**Pinole / Hercules
Wastewater Subcommittee
AGENDA
8:30 a.m.
April 17, 2014
Pinole City Hall
2131 Pear Street
Pinole, CA 94564**

**SUBJECT: PEER REVIEW AND VALUE ENGINEERING REVIEW
OF PLANT UPGRADES**

WATER POLLUTION CONTROL PLANT UPGRADE PROJECT

Peer Review of Pre-Design Documents

Excerpt from Figure 5-5; Alternative 1 HW Changes (full size available in Appendix)

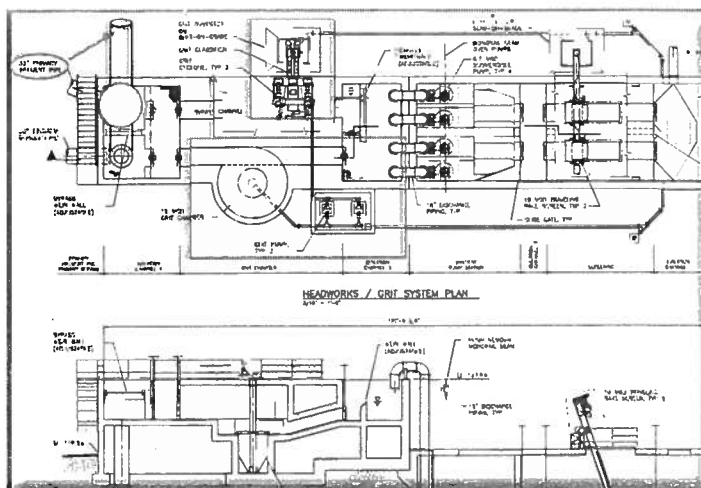
The Review Team's primary recommendation for this area is **HW-1**, to eliminate the 30-inch diameter bypass weir and pipeline from the design. Instead of routing two 30-inch diameter pipelines from the Headworks Structure, the Review Team recommends that HDR consider designing one pipeline to the Primary Clarifier Splitter box and modify

the splitter box to handle the additional flow. The flow will then be routed through a new pipeline that connects with the existing Primary effluent pipeline, located southeast of new Secondary Clarifier No.1 (SC1). This re-routing will eliminate the new 30-inch diameter bypass piping, that is now shown to be installed outside of the plant fencing under the adjoining pedestrian pathway and PC3's effluent discharge pipeline, refer to attached *figure 5.5* for more detail.

Recommendations HW- 2 through HW- 5 focus on reconfiguring the grit system and equipment. Relocating all of the equipment to the north side of the new structure will provide better access for the WPCP's Operations and Maintenance Staff. The new location will also result in the installation of a conveyance system that can consolidate the rags and grit into a single container, covered with odor control ducting. Refer to attached *Figure 5.5* for more detail.

Excerpt from Figure 8-13; PC3 (full size available in Appendix)

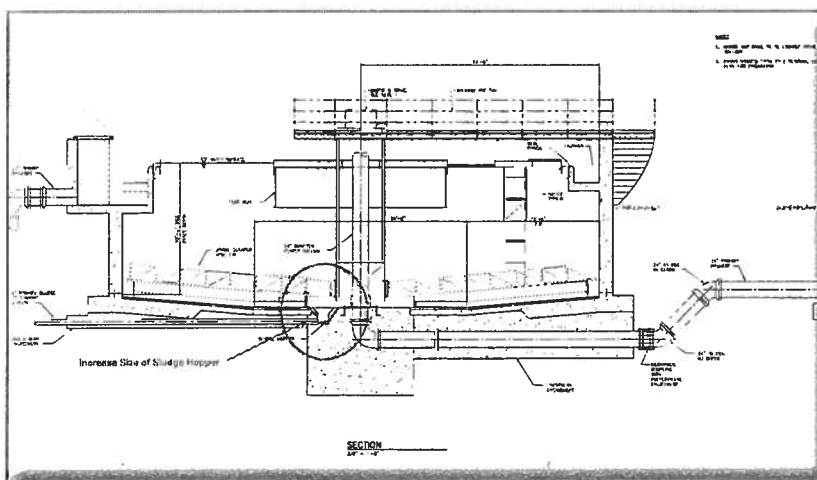
Recommendation PC- 2, enlarging PC3's sludge hopper will help better achieve the design and operational goal of thickening the sludge in the primary process. A larger hopper will also allow a more consistent rate of pumping sludge to the Solids Handling facility.

Excerpt from Figure 14- 16 Retrofitted Effluent Pumping Station (full size available in Appendix)

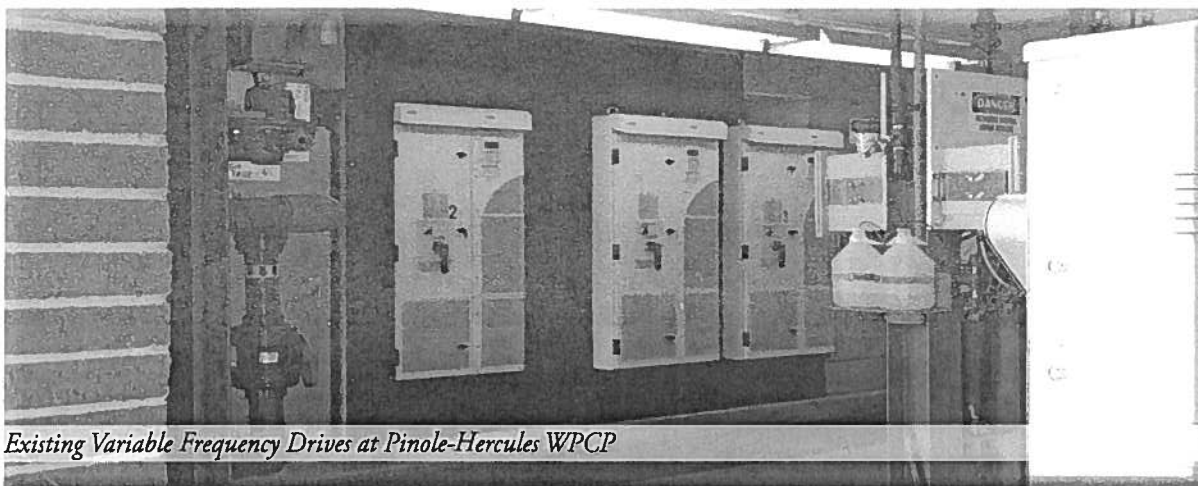
Recommendation EP- 1 is an area that has large potential cost savings over a 20- year operational horizon. The pre-design requires the addition of three new 400-hp motors to pump anticipated wet weather flows while maintaining appropriate redundancy. The Review Team confirmed with WPCP Operations that it is very rare, in the current plant configuration to operate more than one 200Hp. Existing and predicted future minimum night flows are approximately 1.5 mgd, which with the new proposed 400Hp configuration has the high potential to operate on a start stop sequence. This is based on a review of the pump data, which shows that the 1.5 mgd is below the effective turn down rate of the new pumps. The Review Team recommends a minimum of one lower flow pump be maintained (and possibly two), which would handle approximately 90% of the pumping conditions. The third pump would be used during maximum wet weather flows. If there is concern with wet weather pumping redundancy, then the Review

Team recommends initially installing another 400 Hp pump in its own steel can connected to the existing wet well. The costs of the additional pump will be offset by the energy savings of using the smaller pumps during the vast majority of the year. See *Figure 14-16* for additional detail.
